SFCTA 3/23 Board Item 10 [Final Approval] Amend the Downtown Rail Extension

Memorandum

Subject Mr. Steven Polechronis Memorandum dated February 24

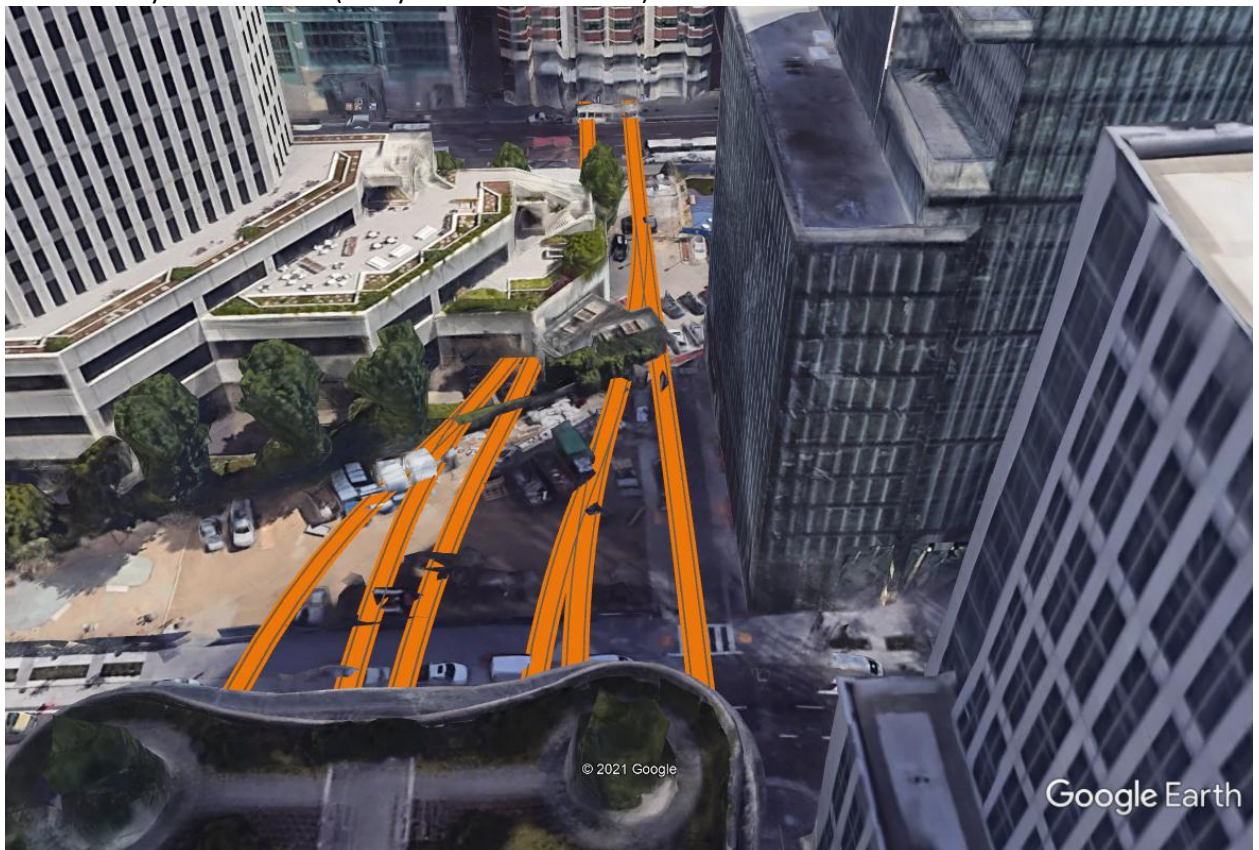
“Link21 program staff made a presentation confirming that an East Bay connection is feasible to the TJPA Citizens Advisory Committee on February 9, 2021.”

The above sentence is a **complete mischaracterization** of what actually transpired at the 2/9 TJPA CAC meeting specifically:

- LINK21 staff correctly identified Alternative 6 (red) as the preferred alignment
- LINK21 staff expressed concerns about a potential conflict with the MUNI tunnel under Embarcadero: <https://www.pmi.org/learning/library/muni-metro-turnback-project-4753>
- **LINK21 staff sought “Ideas and Suggestions” from the CAC** (https://tjpa.org/uploads/2021/02/Item-4_BART-presentation-Link21_CAC_02_09_21.pdf slide 13)

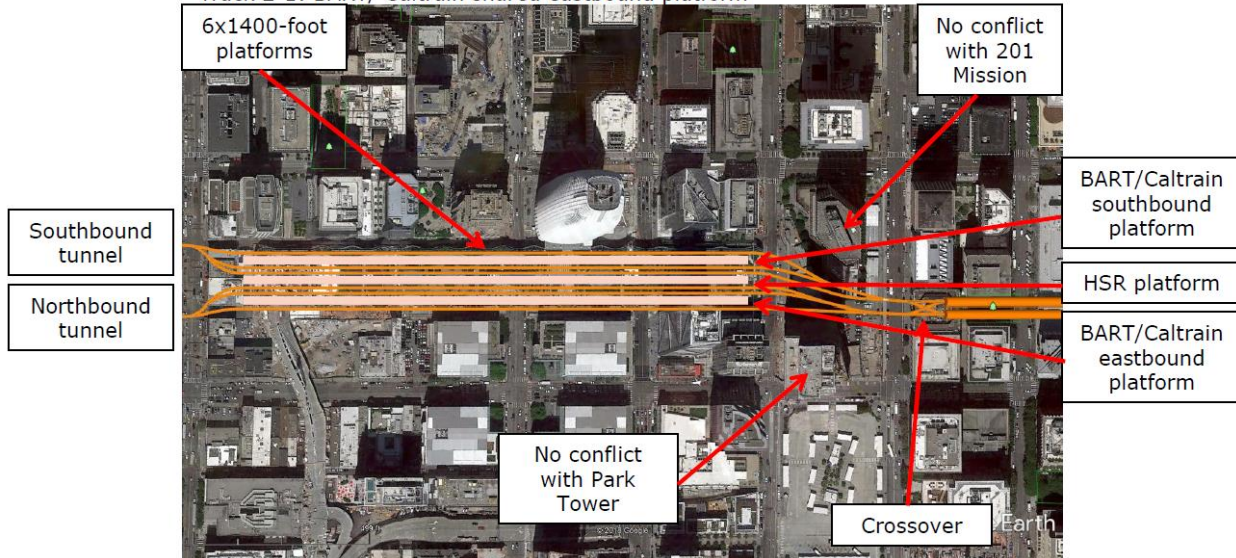
The member of the public also described a tunneling strategy designed to cut the length of construction for the new Transbay tunnel in half (two years instead of four).

- Potential platform assignments (top to bottom)
- Track 6-5: BART/Caltrain shared southbound platform
 - Track 4-3: Dedicated HSR eastbound/southbound central platform
 - Track 2-1: BART/ Caltrain shared eastbound platform

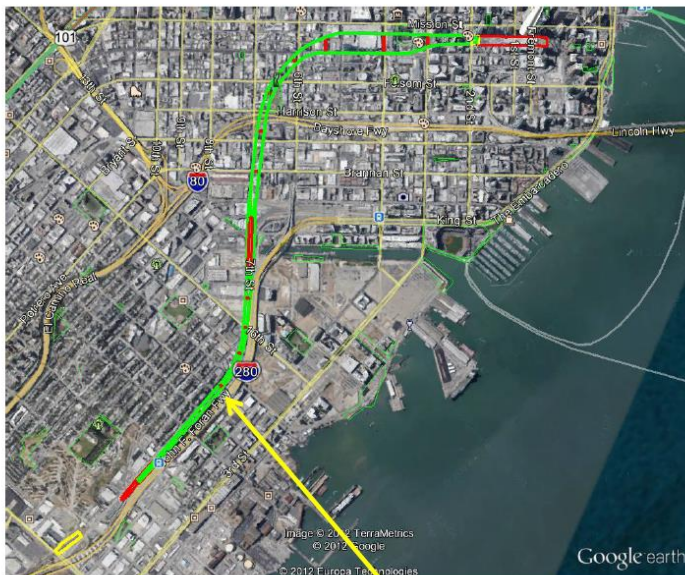
“Linking the schedules of DTX and PAX, as recommended by Mr. LeBrun, would cause years of delay to DTX. There is no approved PAX tunnel to which the tunnel stub box could connect. PAX is currently in its pre-environmental phase; it would need to undergo environmental review and engineering development, and funding would need to be obtained, all of which would be at a yet-be-defined time in the future.”

As can be seen in this 8-year-old “Rethinking DTX” slide, the PAX (formerly “DTX South” was conceived as an integral part of the DTX approximately 18 months BEFORE the initiation of the 5-year “RAB study”. Cost savings in excess of \$300M are achievable because the PAX tunnel boring machines can continue seamlessly to the Transit Center without a “tunnel stub box” and/or track construction/demolition/reconstruction.

Mission Bay station (7th & King)

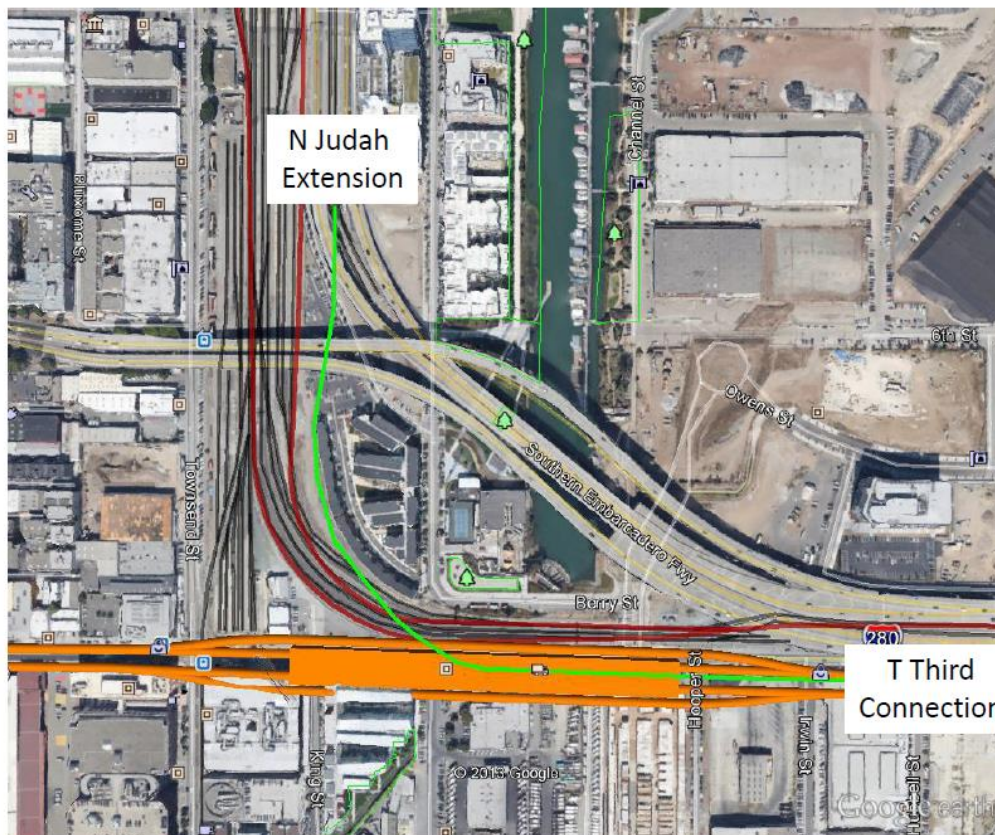
“The Fourth and Townsend Street Station on the DTX alignment, located in the heart of Central South of Market (SoMa), is adjacent to the existing 4th and King Metro Station and the new 4th and Brannan Station on the Muni Central Subway/T Third Line.”

As can be seen from the next slide in the “Rethinking DTX” presentation, seamless (AKA “Vision Zero”) integration between Caltrain and Muni light rail and buses can be achieved by extending the N line and the 16th Street turnback tracks, neither of which is possible without the PAX grade separations at 16th Street and Mission Bay Drive.

The only things that have changed in the last 8 years is that the 1,000-foot platform lengths were shortened to 700 feet and the proposed station was shifted south to provide seamless transfers between Caltrain and the future 16th Street/UCSF BART station (the 7th Street Caltrain station no longer conflicts with the SFPUC Folsom Area Stormwater Improvement Project: <https://sfwater.org/index.aspx?page=1223>).

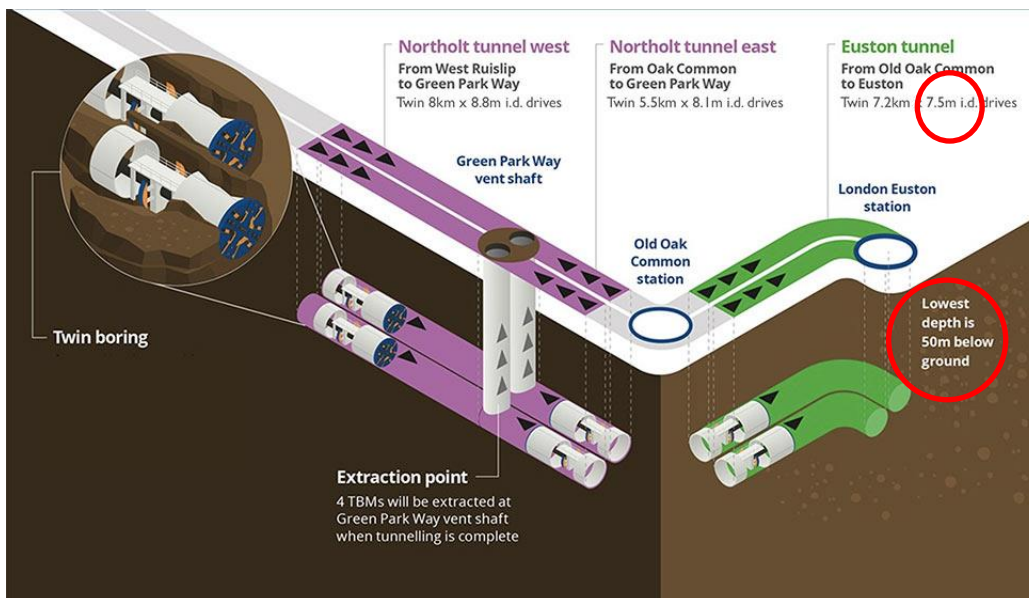
“More right-of-way impacts would occur on Minna and Natoma streets as the available public right-of-way on these very narrow streets is not wide enough to accommodate the tunnel envelope, which would require permanent underground easements under buildings along the streets.”

THIS IS ABSOLUTELY FALSE. The primary criteria for the Minna and Natoma alignment feasibility study was that the tunnel lining and the tunnel shield would fit within the existing right of way without impacts on adjacent properties. As can be seen below, urban tunnels have much

smaller diameters than high speed tunnels (8.15m = 26.75 feet).

*“Two machines will drive the 7km x 7.55m i.d. Euston Tunnel between the route’s southern terminus at a redeveloped Euston Station, and Old Oak Common Station – both in London. The concrete segmental lining is anticipated within the current design at between 350–450mm, for a **TBM OUTER SHIELD DIAMETER for the Euston Tunnel of 8.25-8.45m.**”*

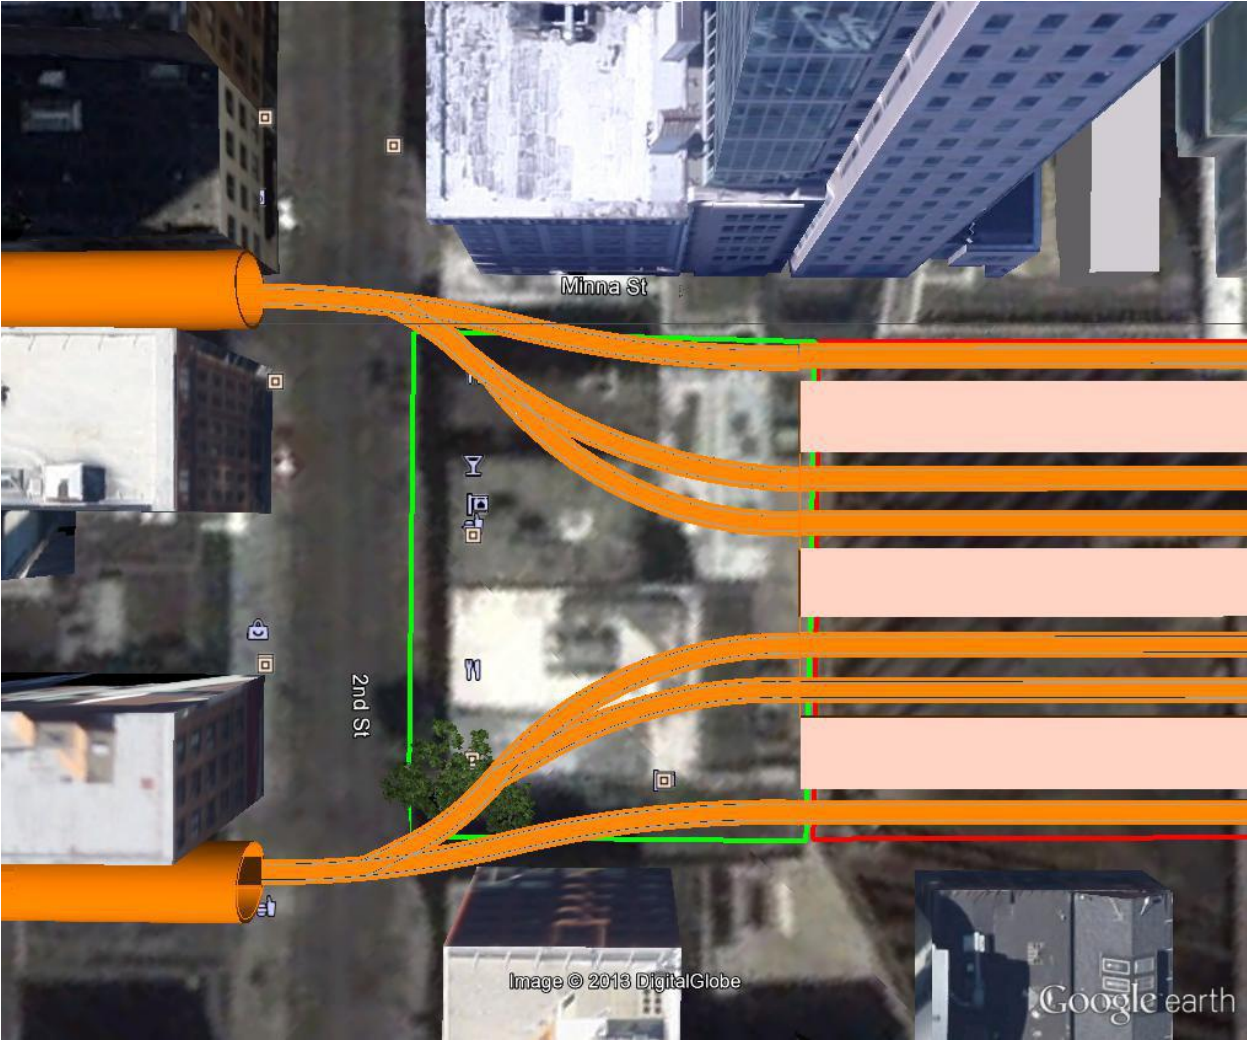
“Finally, the wider footprint of the throat structure, to the west of the transit center in Mr. LeBrun’s concept, would affect additional properties, requiring demolition of these properties to construct the structure.”

The above statement is indicative of an apparent lack of familiarity with the 7th street alignment approach into the Salesforce Transit Center as described on page 48 of the 2018 SEIR (https://tjpa.org/uploads/2018/11/Vol-2-TJPA-Final-SEIS-EIR-App-A-Part-2_11-18.pdf), specifically that the “wider footprint of the throat structure” is actually much smaller than the 2nd Street throat structure being proposed by the TJPA because the throat has been split into two (one northbound and one southbound) “mini throats” each consisting of 3 tracks instead of a gigantic 6-track throat extending from Natoma to Tehema as proposed by the TJPA.

This design opens an option of not having to demolish any properties between the Transit Center and Second Street.

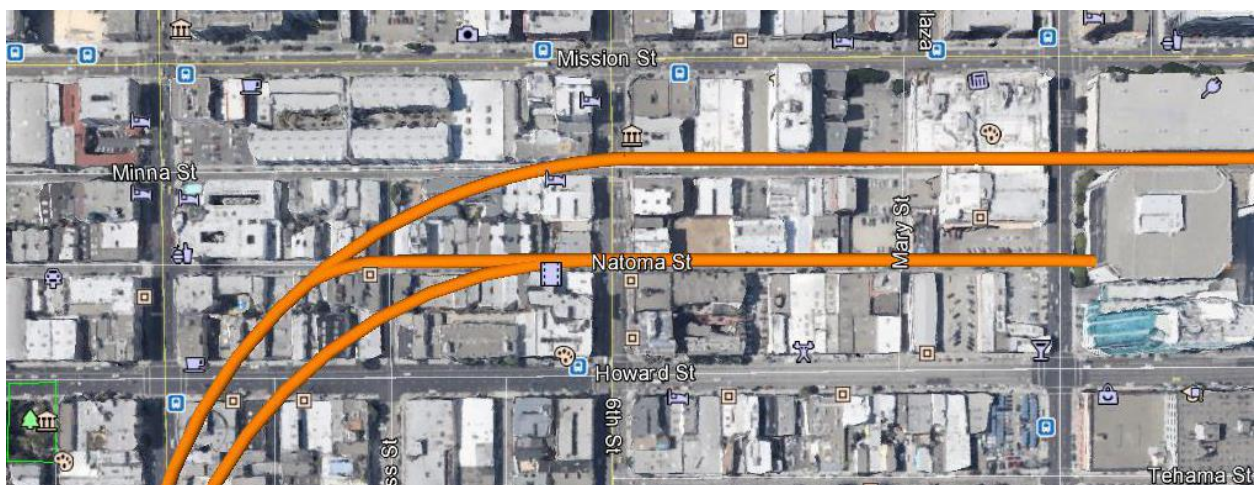
“The two single-track tunnels proposed would constrain operations, create safety risks, and pose maintenance challenges. In February 2018, SFCTA’s peer review panel, made up of five construction, operations, and maintenance experts, identified a need for three tracks into and out of the station to allow for anticipated operational inconsistencies without affecting train travel up and down the Peninsula main line (https://tjpa.org/uploads/2018/04/Item15_SFCTA-Peer-Review-of-DTX-Operational-Studies.pdf).”

THIS IS ABSOLUTELY FALSE.

Please refer to page 15 of Appendix 2.5 of the 2018 Peer Review Report (attached) which correctly identified that HS1 has only two tunnel tracks leading into St Pancras station.

Please also note that the HS1 twin bores service a total of nine (six International and three Domestic) High-Speed platform tracks (Domestic platforms 11-13 are visible in the top right of the picture) as depicted in the following St Pancras International platform and track layout.

Please additionally note that the 12 trains/hour/direction timetable on page 6 of Attachment 4 (Northbound DTX refined alignment (2013)) only used the 3 domestic platforms tracks (half of the capacity of the Salesforce Transit Center).

The red tracks are the six Eurostar platforms tracks on slide 15 of the SENER presentation. The bottom three tracks are the Domestic platforms serviced by SouthEastern High Speed.

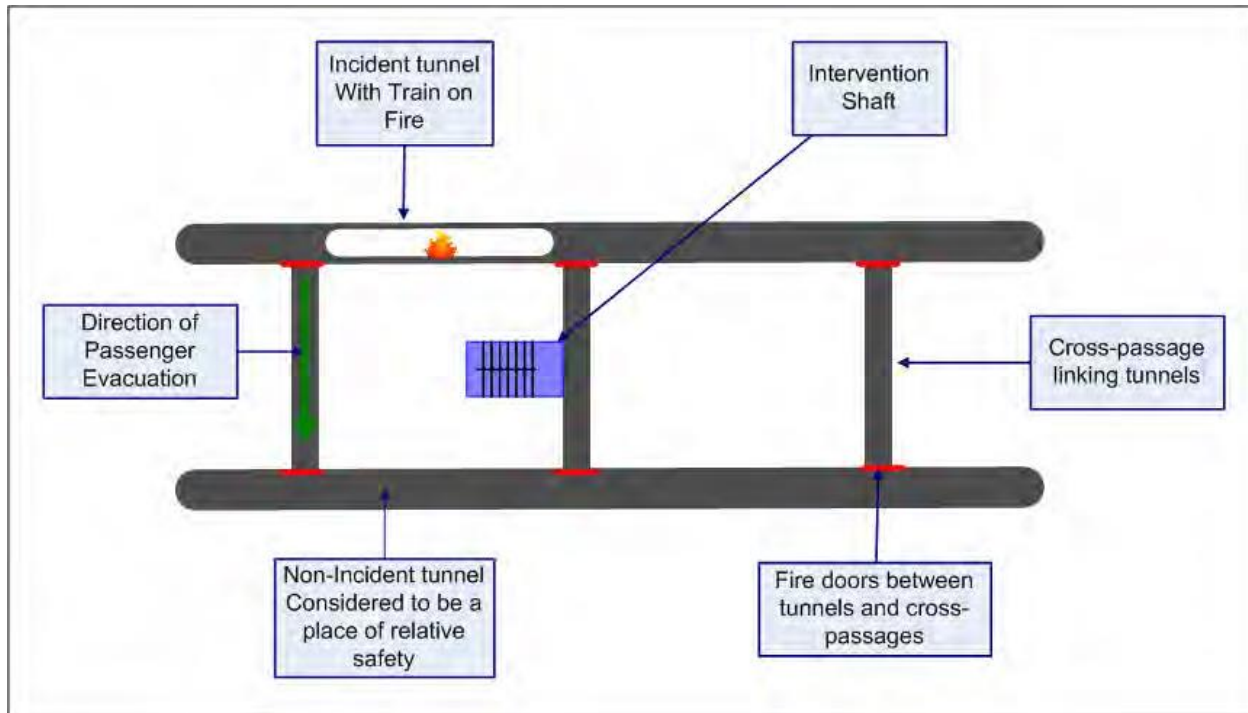
Because of their length, more of these cross-passages would be needed because the required time for egress would increase dramatically. Locating additional cross-passages would be technically and

financially difficult due to the large number of existing buildings with deep foundations and below-grade parking along Mr. LeBrun's proposed alignment.

Right-of way impacts would also be substantial if emergency egress/ventilation structures were selected, as this would require the acquisition and demolition of multiple buildings along the length of Minna and Natoma streets.

As can be seen from the above picture, longer cross-passages create superior opportunities for flexible shaft locations. Potential intervention locations are 2nd Street vent shaft, Moscone crossover, 6th Street crossover, 7th/Street station north headhouse, 7th Street station south headhouse and 22nd the Street PAX portal.

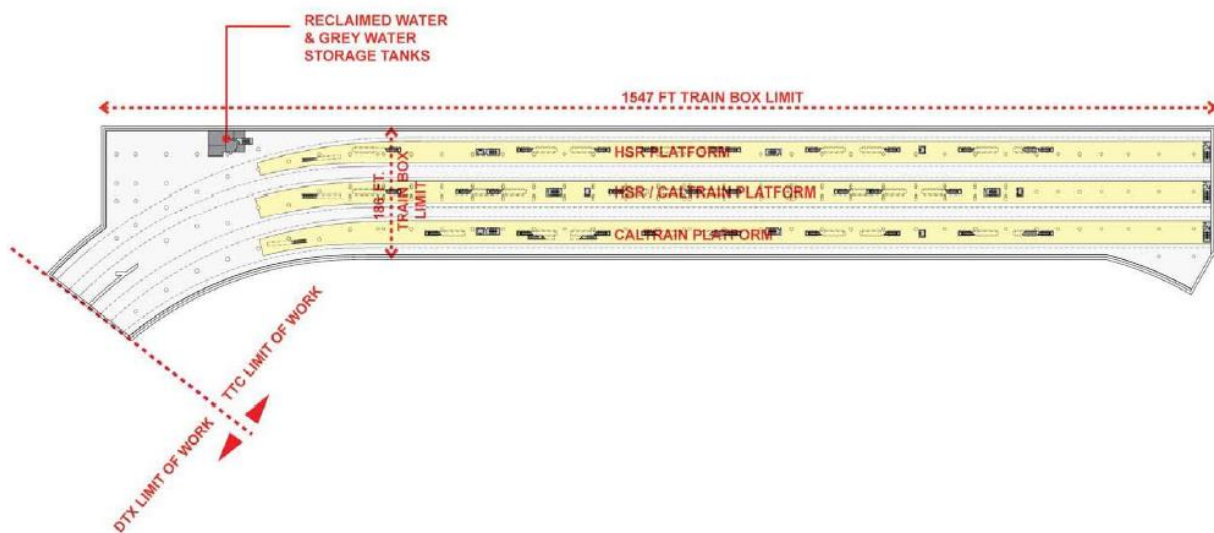
The location of the 7th Street station also provides an opportunity to develop a Rive Gauche/Rive Droite (Left Bank/Right Bank) walking experience along China Creek akin to the River Seine in Paris which would be the preferred route according to an informal poll of BallPark patrons when asked whether they would rather transfer to MUNI light rail or walk to the Ball Park.

Last but not least, the 7th Street/UCSF station delivers on the Planning Department's vision of a "Mission Bay" Caltrain station without any impacts on the recently constructed T-Third extension.
